# Glen Innes to Tamaki Drive Shared Path: Summary of your feedback on the Ōrākei Basin boardwalk balustrade

November 2018

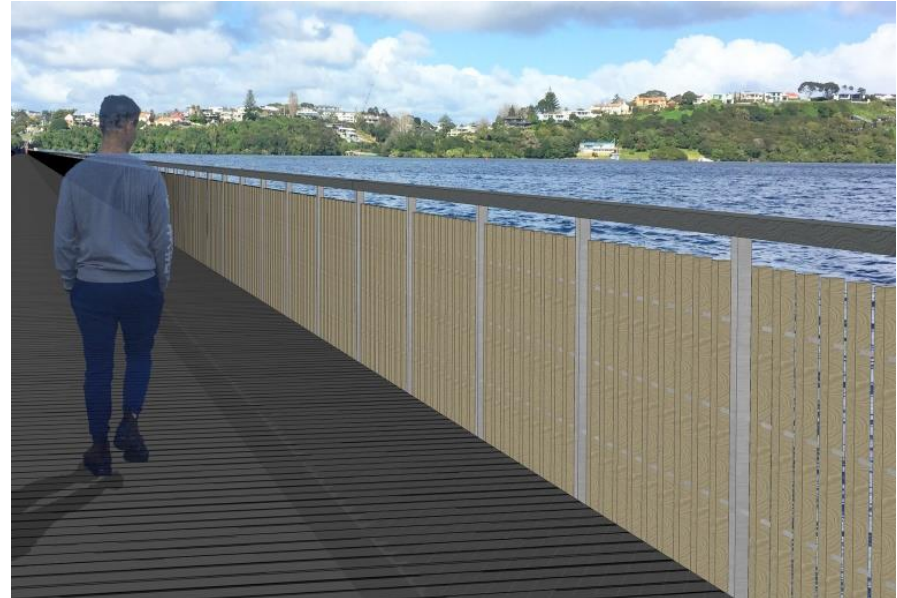
▼ **Style 1:** *This style consists of a timber top railing, timber posts and a metal infill. A gap will be created beneath the top railing to further allow 'see through'. The metal infill will either be black or a shade of silver.*

▼ **Style 2:** This style consists of a timber top railing, metal posts and a metal infill. A gap will be created beneath the top railing to further allow 'see through'.

▼ **Style 3:** This style consists of a timber top railing, metal posts and a timber infill.

- You felt Style 1 was a less intrusive design that provided better views and connectivity to the surrounding environment (33%).
- You also liked the overall aesthetics (27%), and that the style is more in keeping with its context (17%). You also liked the mix or choice of materials (14%).

- You felt Style 2 was a less intrusive design that provided better views and connectivity to the surrounding environment (62%).
- You also liked the overall aesthetics (16%), the likely durability of the materials/ease of maintenance (8%), and that the style is more in keeping with its context (6%).

- looked good (19% of all comments); and
  - were more natural and in keeping with the surrounding environment (17% of all comments).
- Of the three styles offered, Style 3 was the least preferred because of the thickness of the wooden infill and its likely impact on views. For example: *“Its [sic] more NOT option 3! The timber infill (as per the pic) is too strong. The metal infill is open and gives a lighter feeling.”*

As part of the initial feedback, you told us that you preferred a lower balustrade, and 56% of all your comments subsequently reflected this. We obtained dispensation partway through the consultation to deviate from the design standard which could enable the balustrade height to be reduced from 1.4m to 1.2m high on this section.
